File: P-3295

April 20, 2023

Re: Planning & Development Committee Meeting - April 24th, 2023
Agenda Item No. 7.1
Amendment to the Credit Valley Secondary Plan (Springbrook Tertiary Plan)
Cal Markell Development Inc.
1724-1730 Queen St. W.
City of Brampton, Region of Peel

SCHEDULE SP45(b) Springbrook Settlement Area Tertiary Plan

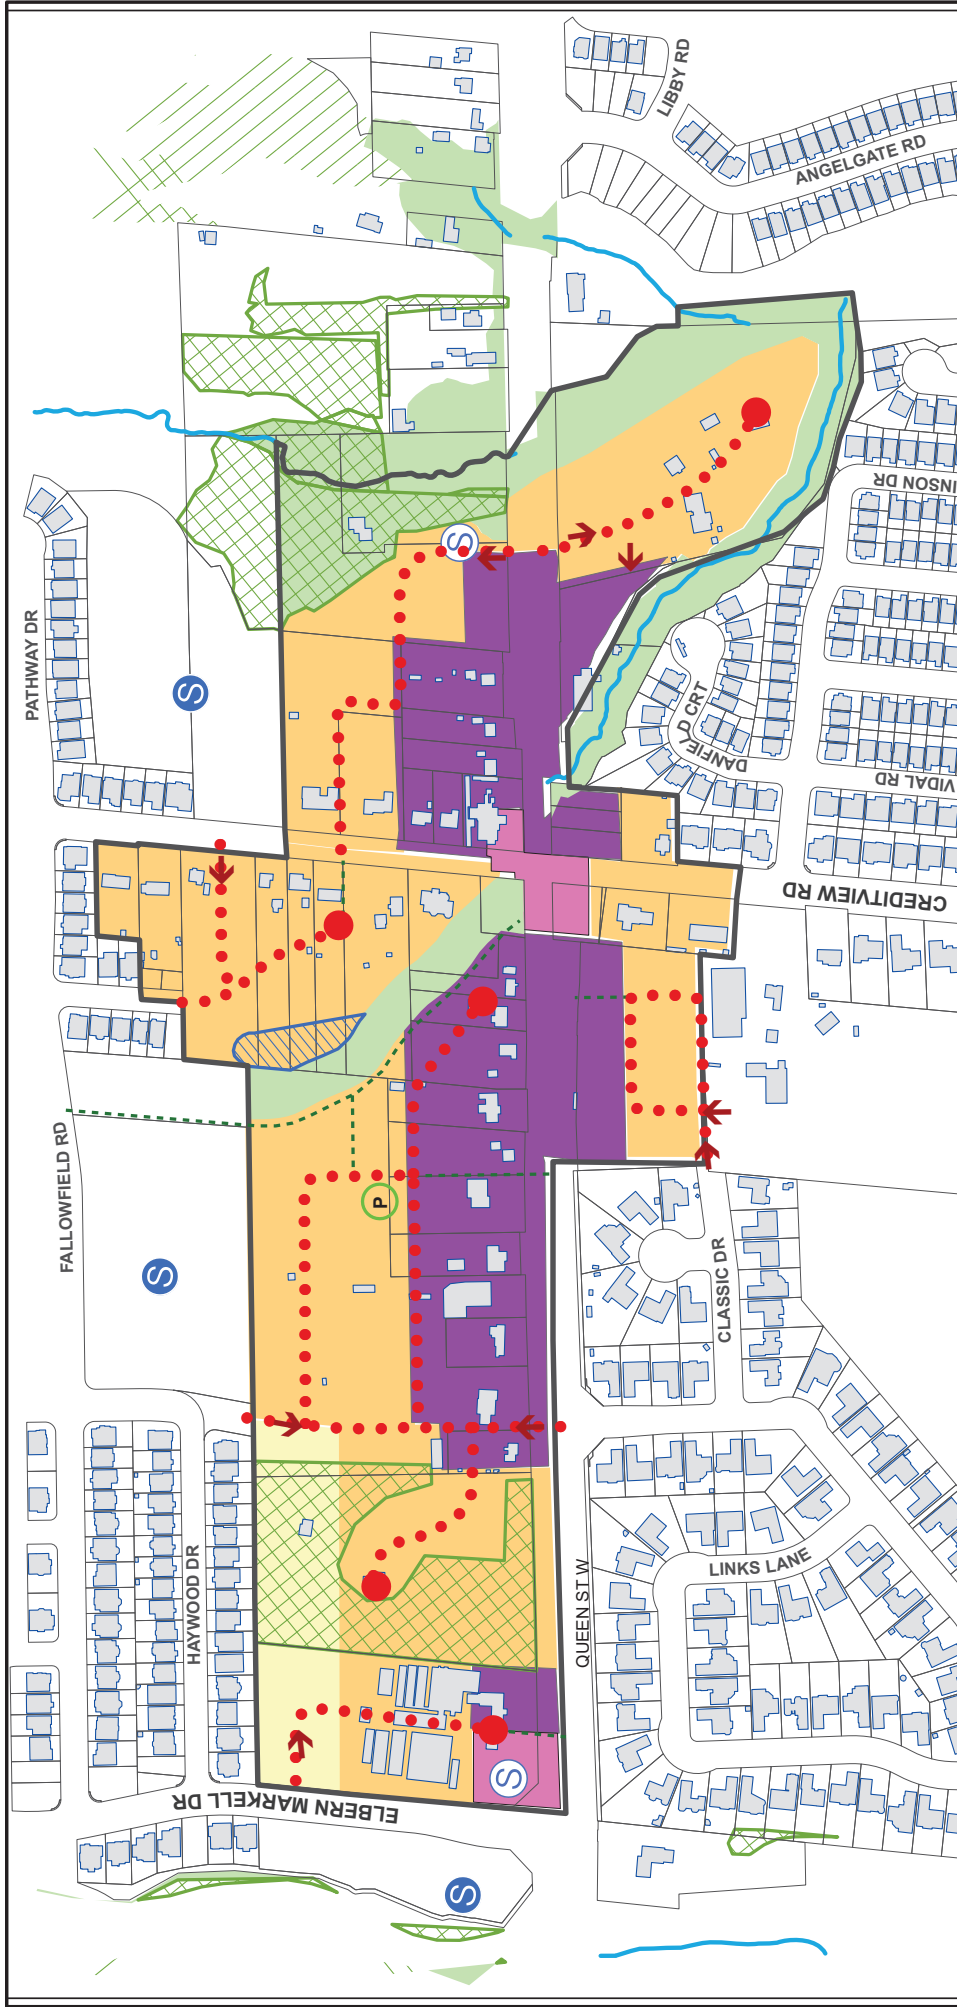
Upon review of the proposed Tertiary Plan, Schedule SP45(b) does not reflect the applications in process for the subject lands, as it proposes to designate the subject lands a combination of “Low Density Residential” (permitting single detached, semi-detached, and townhouse dwellings), Low-Medium Density Residential” (permitting single detached, semi-detached, and townhouse dwellings), Medium Density Residential” (permitting up to 12-storey apartment building forms), and “Mixed-Use Medium-High Density Residential” (permitting up to 14-storey apartment building forms with required ground level commercial). A stormwater management pond (subject to future study) is conceptually shown at the southwest corner of the site closest to the intersection of Queen St. W. and Elbern Markell, and a “Road” is identified internal to the site.

In this case, it is requested that Schedule SP45(b) is revised to remove the “Proposed Stormwater Management Pond (Subject to Further Study)” indication from the subject lands.

It is requested that Schedule SP45(b) is revised to remove the “Conceptual Road” linework from the subject lands.

Considering the above, it is requested that the lands be designated a combination of “Medium Density Residential” for the north portion of the site with a maximum height of three-and-a-half (3.5) storeys in a stacked townhouse form, and “Mixed Use Medium-High Density Residential” (with commercial uses permitted but not required) for the south portion with a maximum height of eighteen (18) storeys and be subject to the application of a 45 degree angular plane from the existing low-density residential uses to the north.

ATTACHMENT 1
CAL-MARKELL ANGULAR PLANE

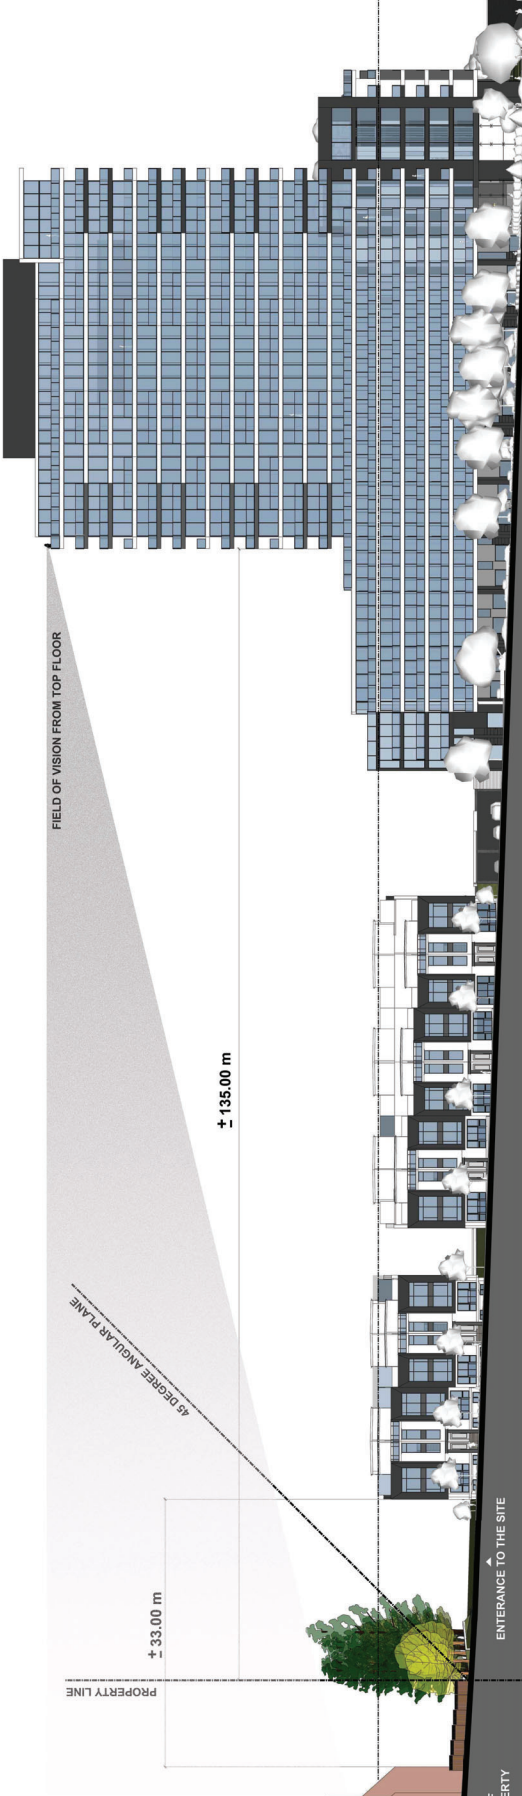
While it is noted that the proposed combination of land use designations on the subject lands is intended to guide suitable built-form transition; the above proposed policies are supportive of a widely adopted approach to apply a 45 degree angular plane as the primary means of achieving an appropriate transition from high density uses to low density residential uses. However, the proposed policies should be refined to clarify that the 45 degree angular plane will be taken from *existing* low density residential uses, and not from Low and Low-Medium Density designated lands. In the instance of the applications in process for the subject site, the proposed eighteen (18) storey building is situated at the southerly low point on the site being closest to Queen Street West, and the transition zone to the existing low density residential uses to the north would contain three-and-a-half (3.5) storey stacked townhouses with a private road and retained mature coniferous tree line beyond. The applications in process for the subject site are fully contained within the contemplated angular plane, in part by virtue of site specific topography which falls away from the existing low density residential uses to Queen Street West (see Attachment 3- Cal Markell Angular Plane).
